ATTACHMENT A

Technical Specifications

Fort Calhoun  
Cycle 12  
License Application

Explanation for Cycle 12 Technical Specification Changes

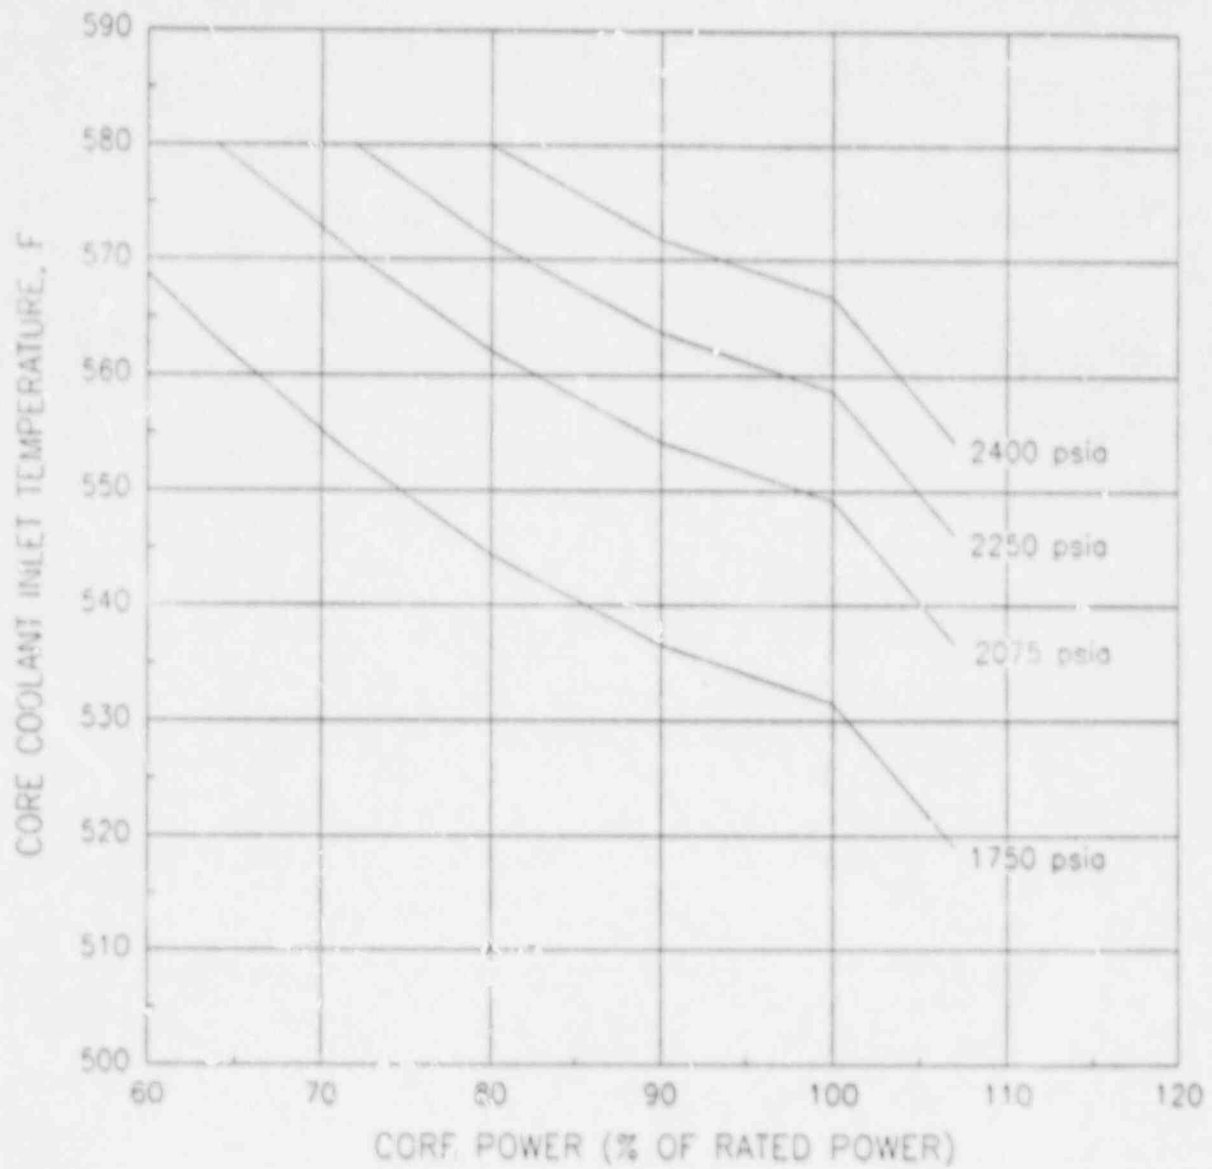
2) Figure 1-3	Replace Figure 1-3 with enclosed Figure 1-3.	The Cold Leg Temperature limit has been changed from 545°F to 543°F. This has resulted in a change to the Alpha, Beta and Gamma term of the TM/LP equation.

The proposed Technical Specification changes in Table B-1 corresponding to Items 2, 11 and 12 for Technical Specifications Figure 1-3, 2.10.4(5) on page 2-57c and Footnote \*\* on Page 2-57c concern lowering the current cold leg temperature ( $T_C$ ) from 545°F to 543°F.

The operation of the unit with a reduced cold leg  $T_C$  will provide additional margin for the TM/LP  $P_{var}$  equation. The Alpha, Beta and Gamma terms of the TM/LP  $P_{var}$  trip equation were optimized given the reduced allowable  $T_C$  and the unchanged  $F_R$  operating parameters.

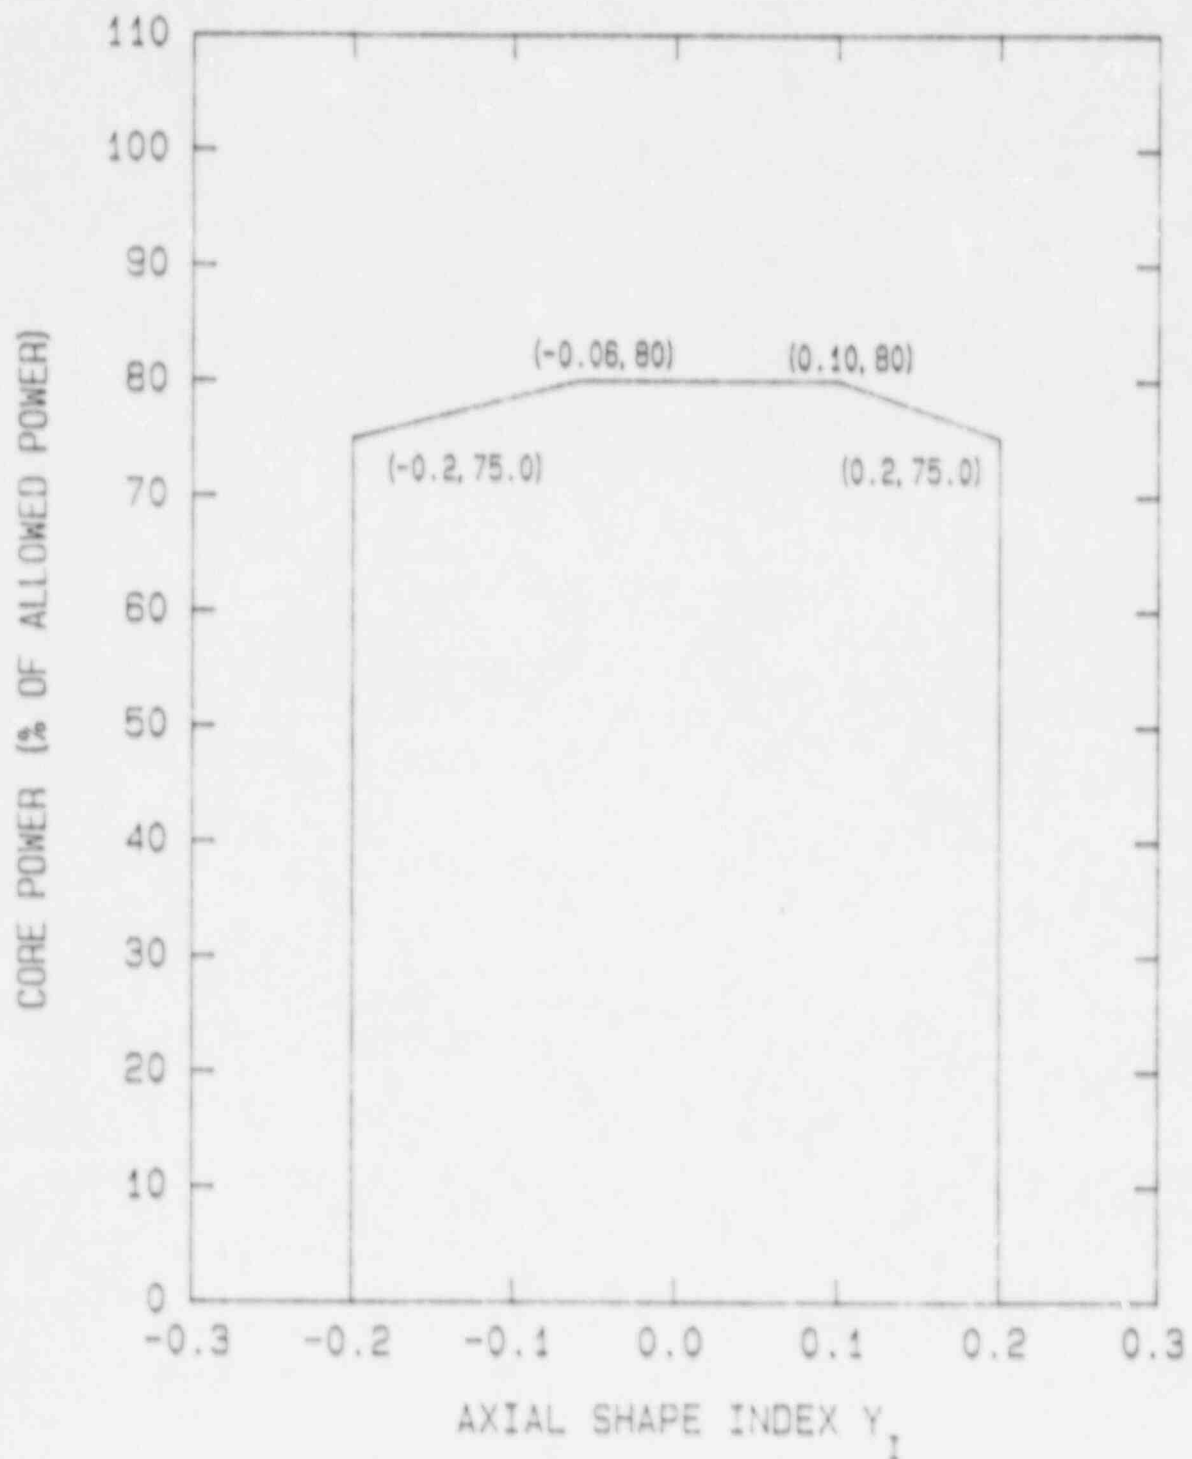
3) Page 1-5	Change the reference from FSAR to USAR.	Reflect updated reference.
4) Page 1-6	"strady" to "steady"	Corrected typo.
5) Figure 2-6	Replace Figure 2-6 with enclosed Figure 2-6.	The LHR-LCO has been revised to reflect the use of the more limiting LOCA ROPM limit in the analysis vs. the transient analysis ROPM. (see Letter LIC-88-620, K. J. Morris (OPPD) to NRC Document Control Desk, dated July 25, 1988).

The proposed Technical Specification changes in Table B-1 corresponding to Items 1, 5, 6 and 10 for Technical Specifications Section 1.1, Figure 2-6, Figure 2-9 and Section 2.10.4(3) on Page 1-2 and 2-57 concern reducing the  $F_{xy}^T$  value from 1.85 to 1.80.

An error in the Cycle 11 setpoint evaluation has reduced the excore LHR-LCO tent from 90% power to 80% power during operation with the excore detectors. By reducing  $F_{xy}^T$ , additional operating margin is gained in the LHR-LCO operating tent. The  $F_R^T$  and  $F_{xy}^T$  limits as a function of power in Technical Specifications Figure 2-9 have been revised to maintain consistency with the change to Figure 2-6.

A review of Technical Specification 2.10.4 with the NRC Senior Resident Inspector indicated that the requirements for entering into the excore LHR-LCO (Figure 2-6) were unclear. The changes made herein more accurately define when the LHR-LCO should be entered, to allow sufficient time for a power reduction to the maximum power allowed by Technical Specification Figure 2-6, should the reactor be in excess of that power level at the time the LHR-LCO was entered.

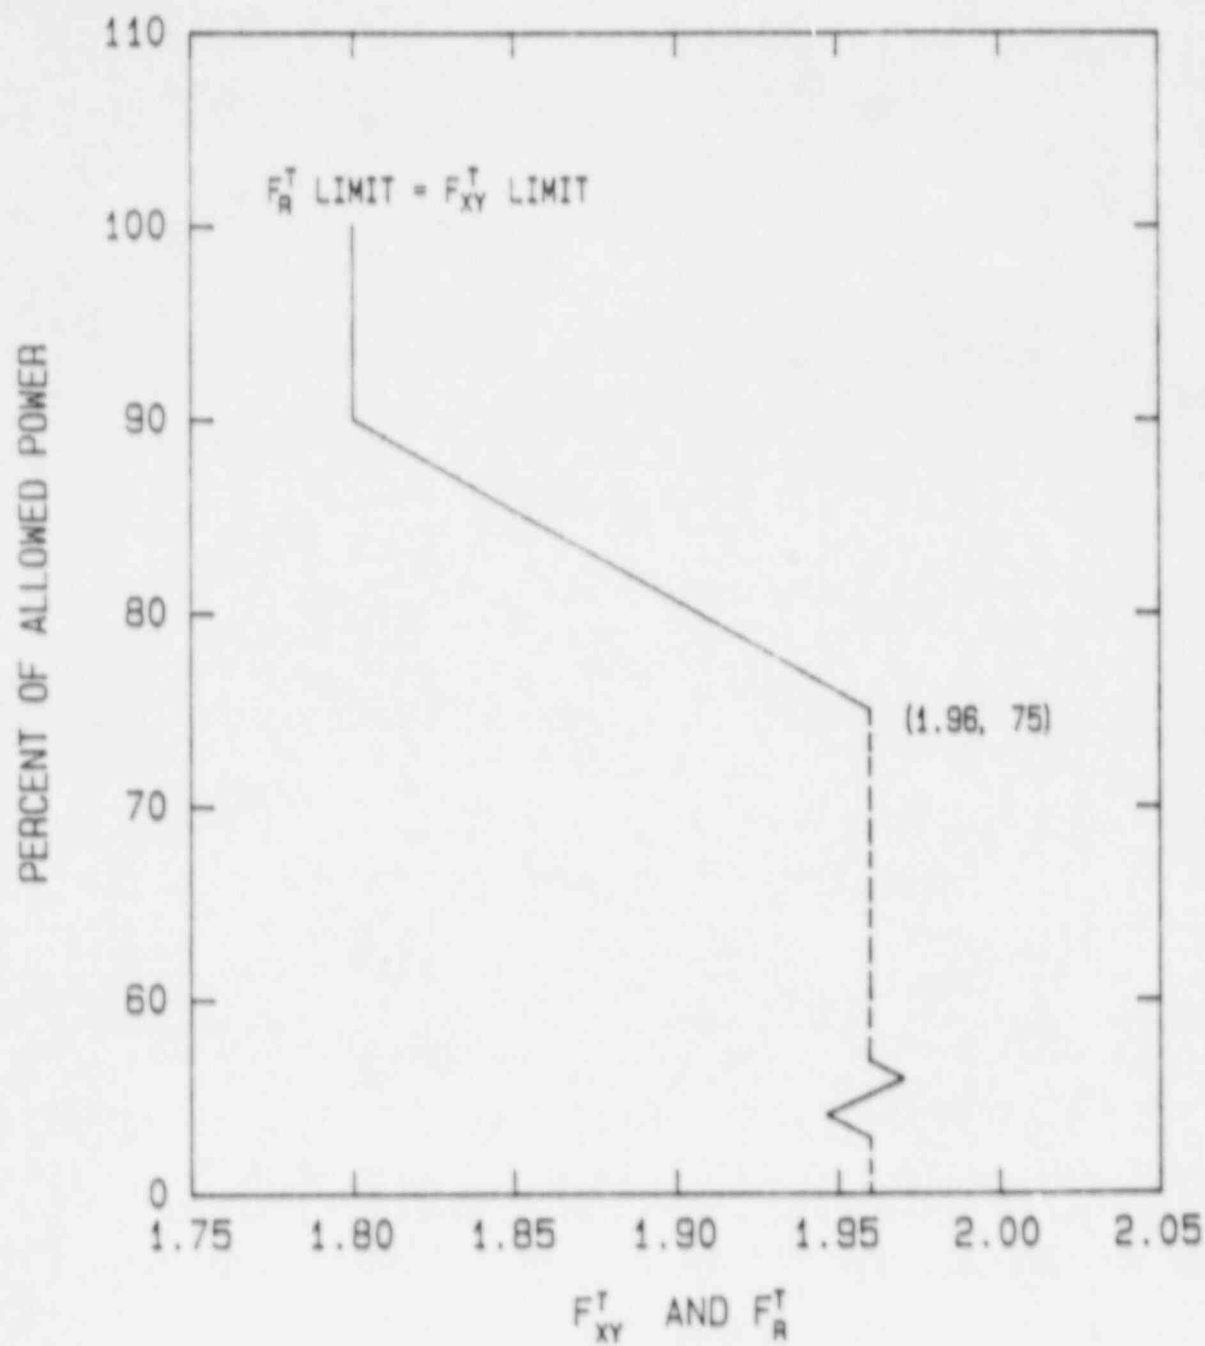
6) Figure 2-9	Replace Figure 2-9 with enclosed Figure 2-9.	The $F_{xy}^T$ and $F_R^T$ limits as a function of power have been revised to maintain consistency with changes to Items 1 and 5, above.
